The Commission has issued the enclosed Amendment No. 58 to Facility Operating License NPF-2 for the Joseph M. Farley Nuclear Plant, Unit No. 1. The amendment consists of changes to the Technical Specifications in response to your application transmitted by letter dated April 20, 1984.

JOSEPH M. FARLEY NUCLEAR PLANT, UNIT NO. 1

Amendment No. 58
License No. NPF-2

SAFETY EVALUATION BY THE OFFICE OF NUCLEAR REACTOR REGULATION
RELATED TO AMENDMENT NO. 58 TO FACILITY OPERATING LICENSE NO. NPF-2

Figure 3.4-2 Farley Unit 1 Reactor Coolant System Heatup Limitations Applicable For The First 7 EPY

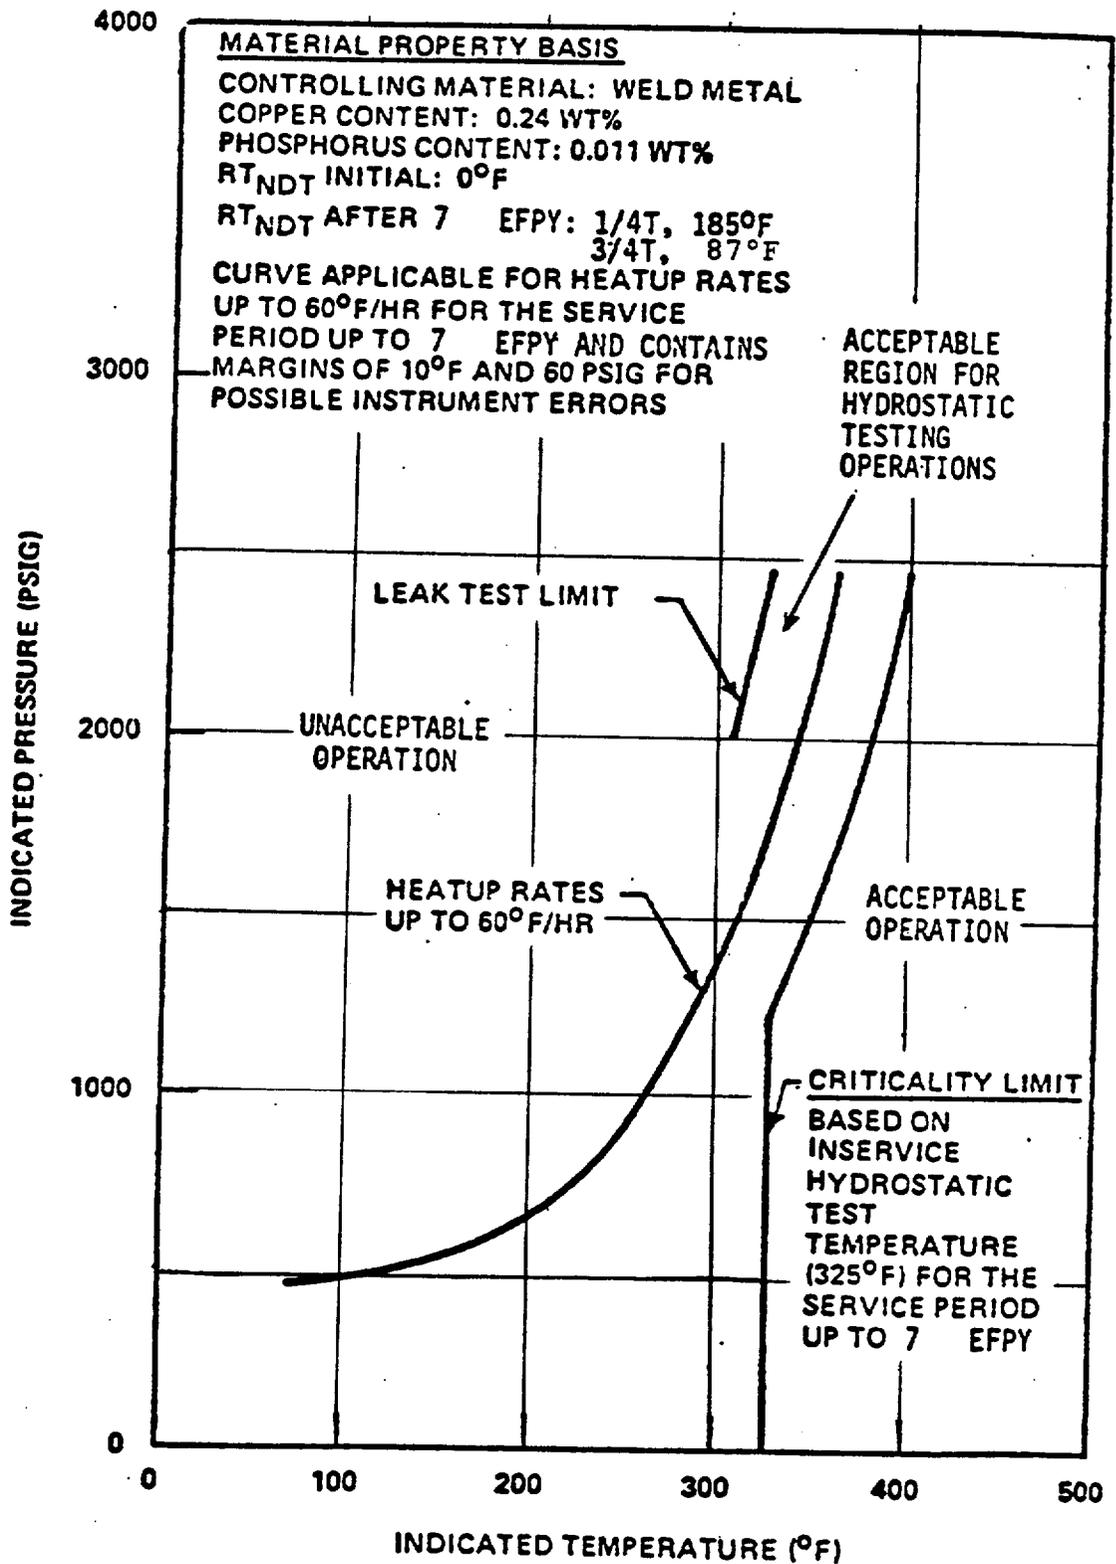
The amendment modifies Technical Specifications (Table 4.4-5 and Figures 3.4-2 and 3.4-3) relating to the reactor vessel material surveillance schedule and heatup and cooldown curves extending the curves to seven effective full power years of operation. These changes are based on WCAP-10474 provided by licensee letter dated March 1, 1984 and are in accordance with 10 CFR 50, Appendix H, published May 31, 1983.

Heatup and cooldown limit curves are calculated using the most limiting value of the nil-ductility reference temperature, RT_{ndt} , at the end of 7 effective full power years of service life. The 7 EFPY service life period is chosen such that the limiting RT_{ndt} at the 1/4T location in the core region is greater than the RT_{ndt} of the limiting unirradiated material. The selection of such a limiting RT_{ndt} assures that all components in the Reactor Coolant System will be operated conservatively in accordance with applicable Code requirements.

flange region of 0°F and 60°F, respectively, we have determined that the proposed pressure-temperature limits are acceptable for 7 effective full power years.
